DATE: September 15, 2023
TO: All Bidders
FROM: Renée Knight, Purchasing Specialist
SUBJECT: Addendum 1 – Bid #658, Oxnard College Campuswide HVAC Project

Bid#658: Oxnard College Campuswide HVAC Project
Addendum #1

DRAWING NUMBER : **E100**

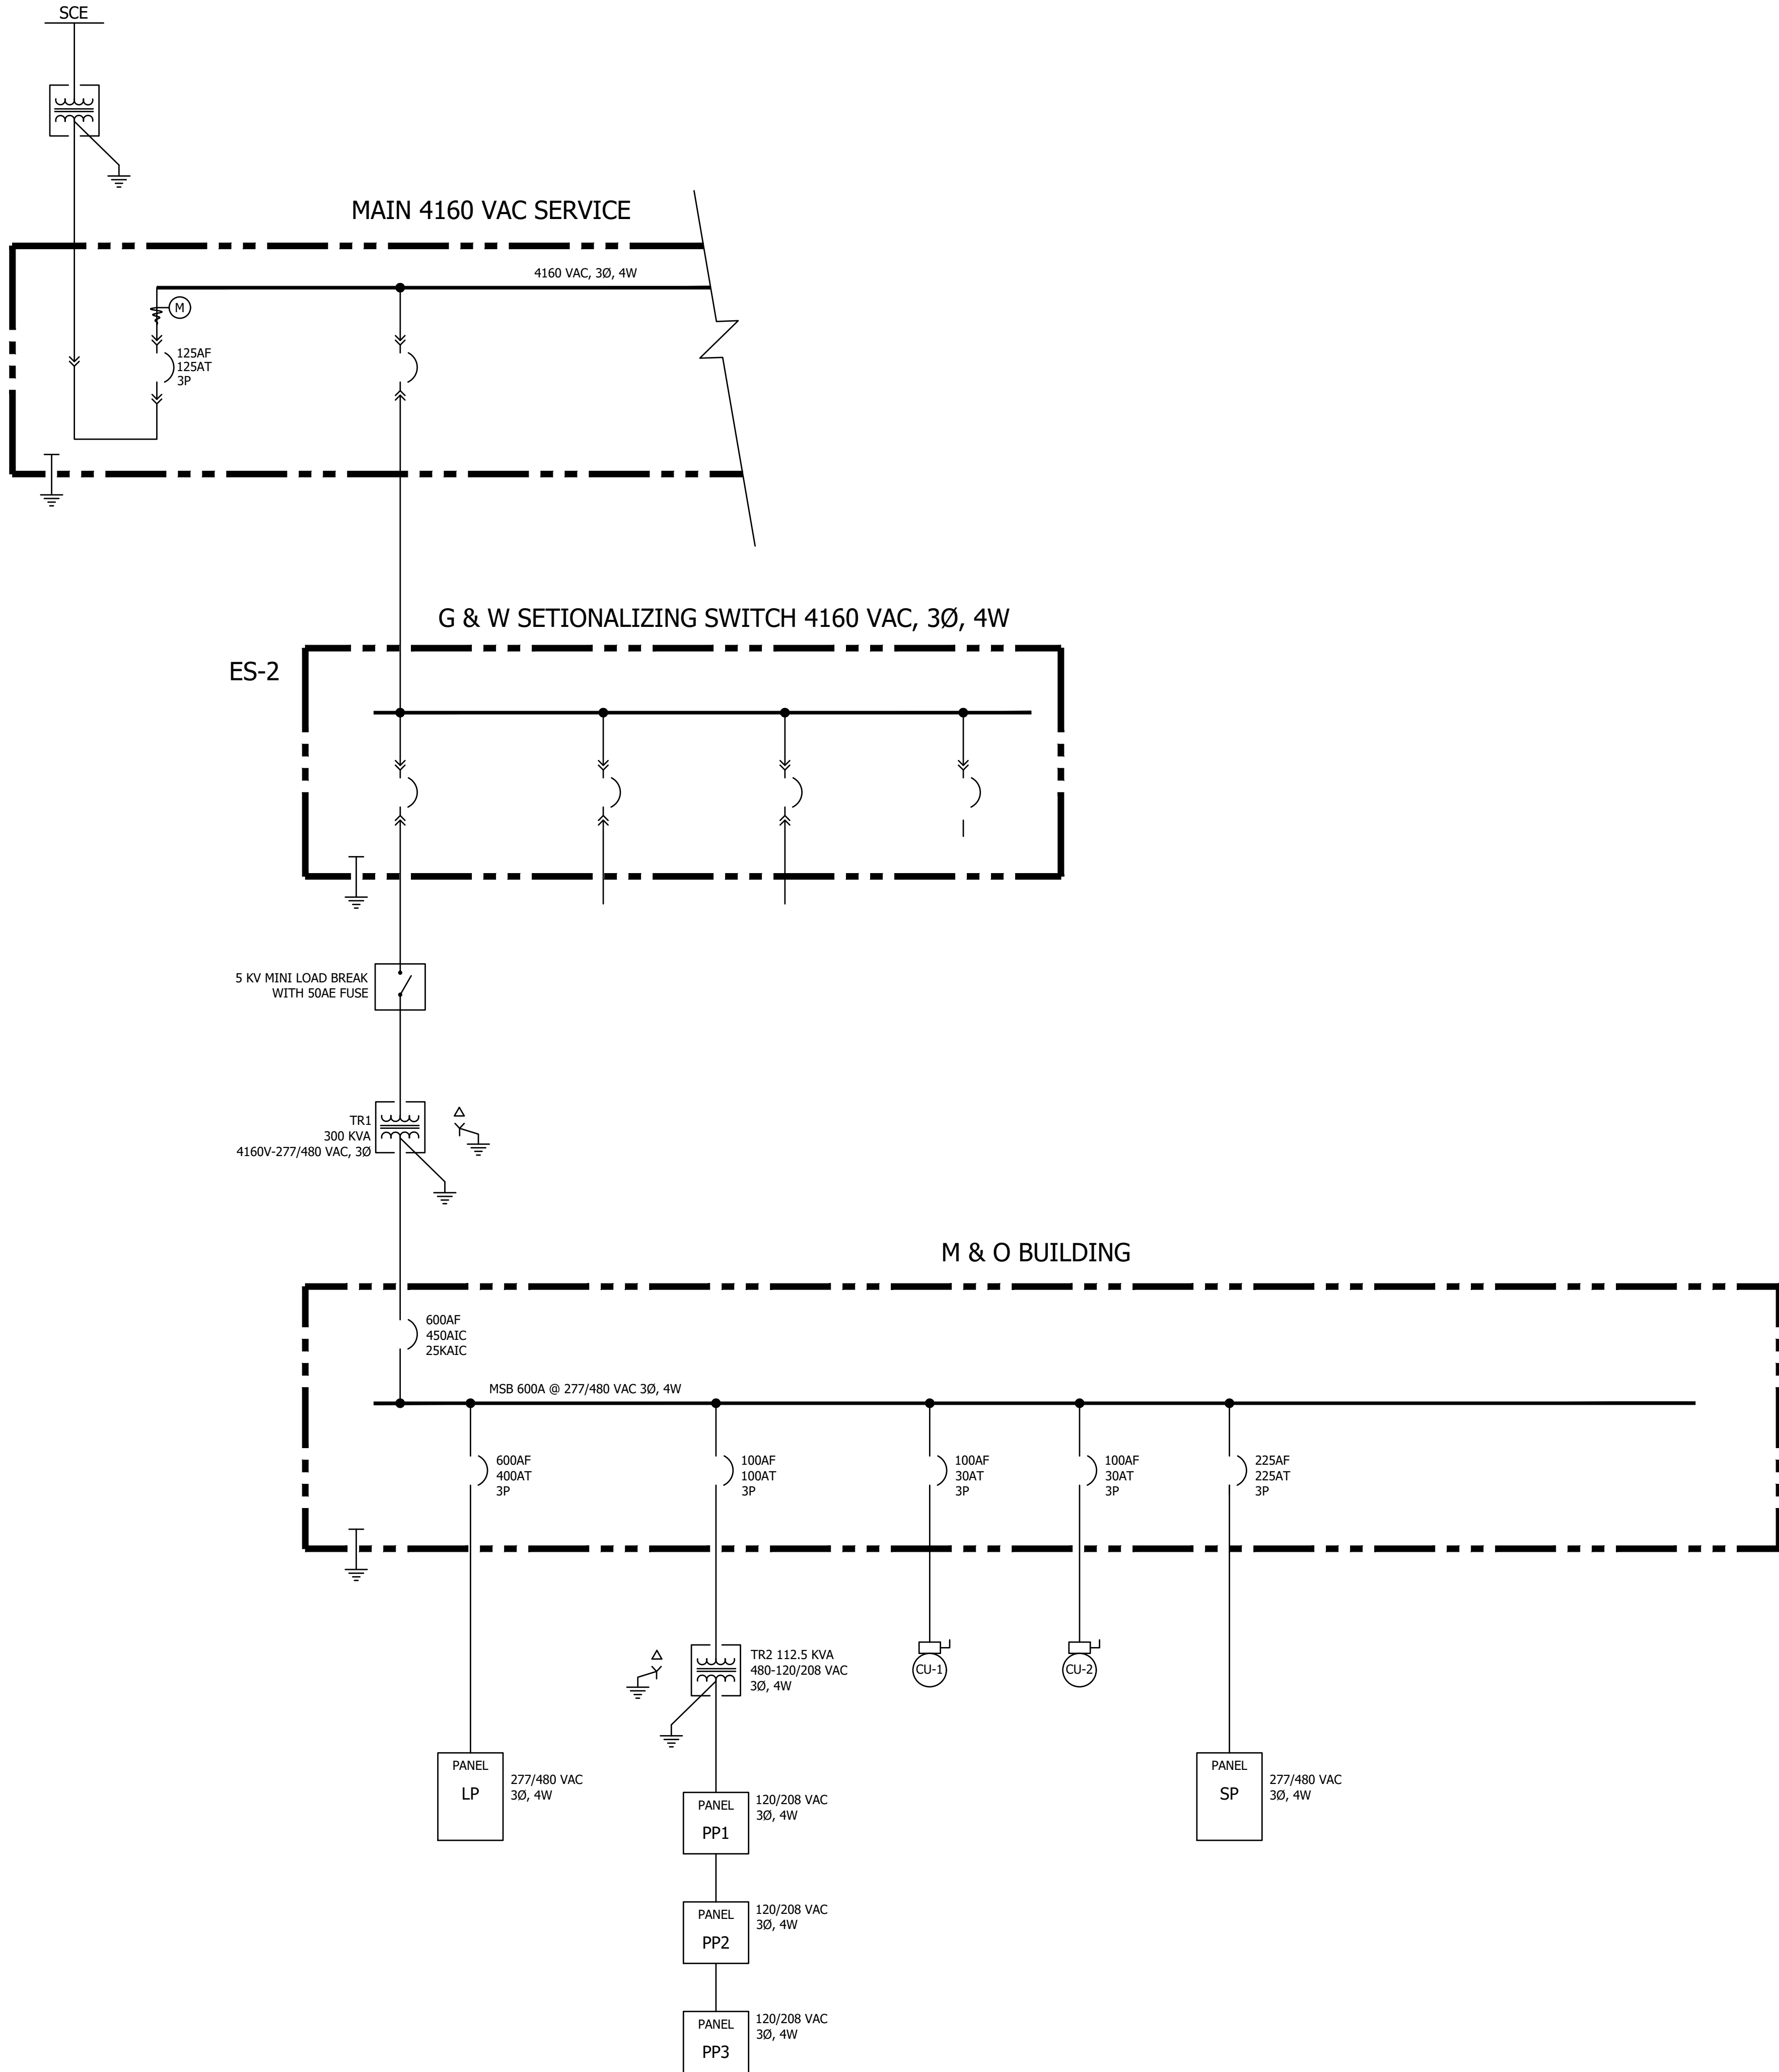
1. See Attached Electrical Plans for Shop HVAC – Sheets E100, E200, E420.
2. Reference sheet M2.0 - Original Child Care mechanical floor plans for duct cleaning and balancing purposes only.

AREA 'A' GROUND FLOOR RENOVATION & ADDITION FLOOR PLAN - HVAC

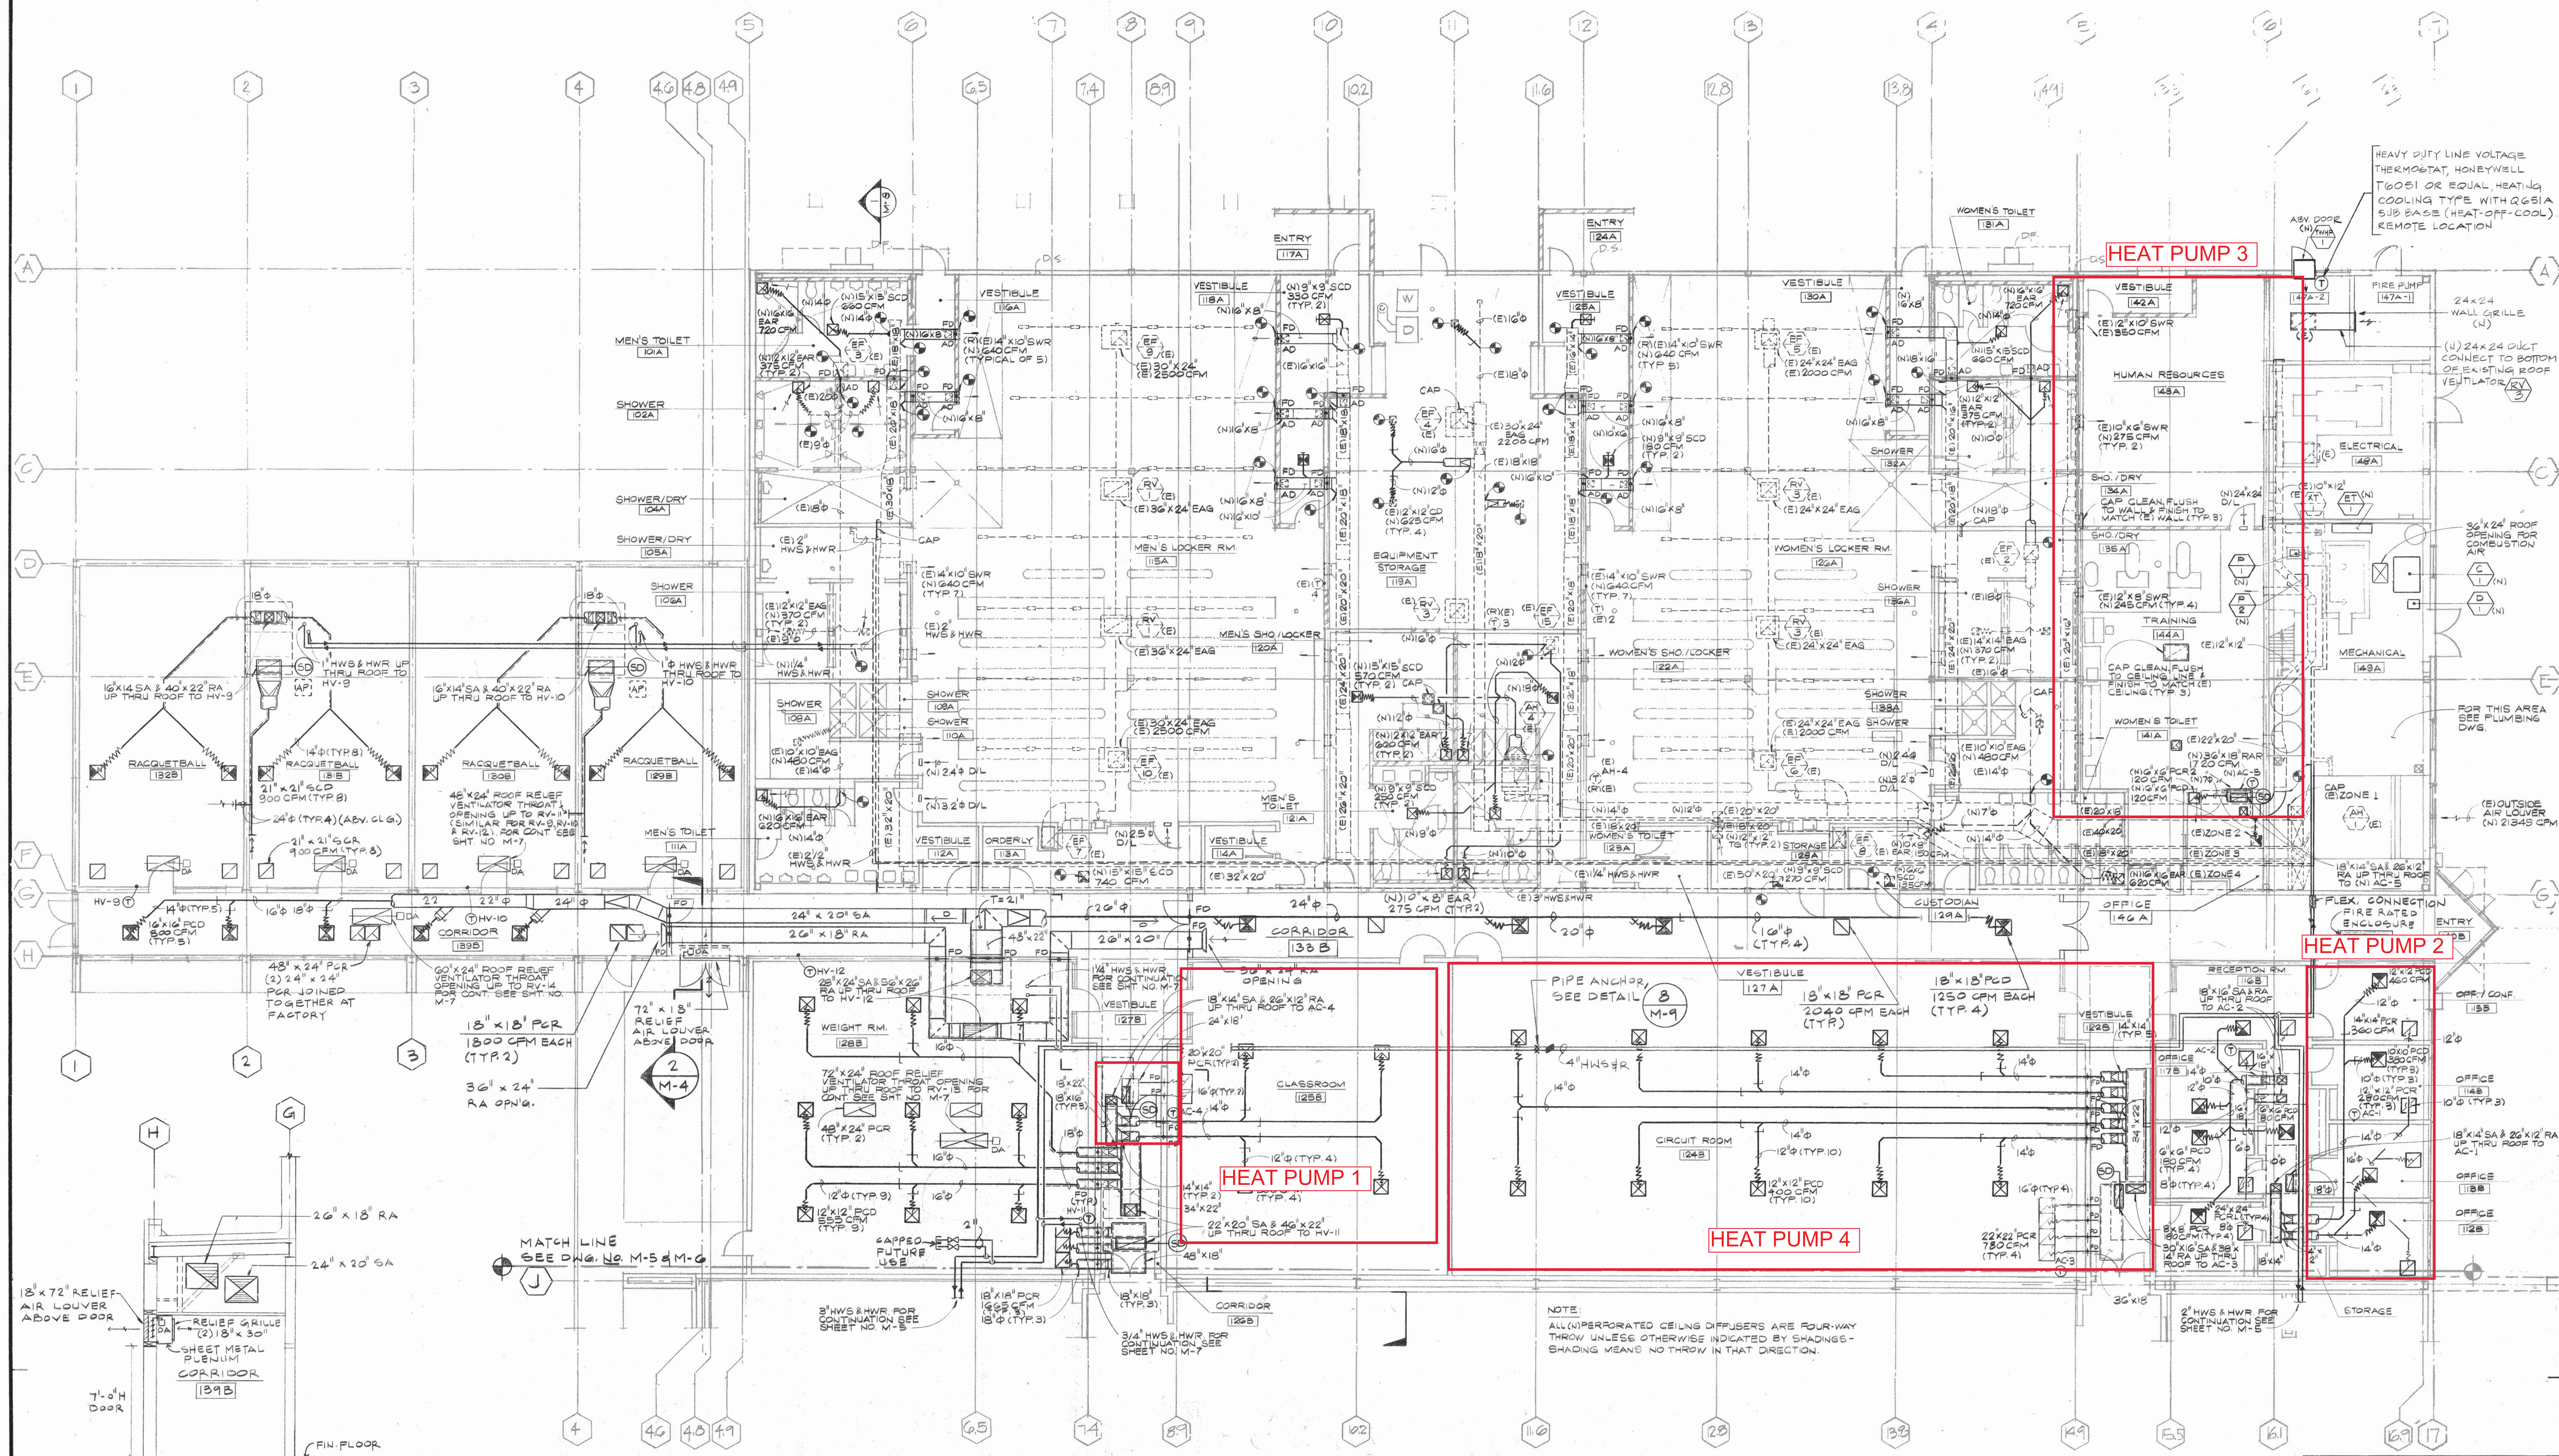
3. Reference Sheet M3.0 - Original Gym mechanical floor plans for duct cleaning and balancing purposes only.
4. Reference M4.0 - Middle High School Duct Sketch for duct cleaning.

6. Reference Sheet M3.0 – Existing Gym HVAC unit replacement.
Remove existing UV Light Systems from existing units and reinstall in new units – typical of 4 package rooftop units.
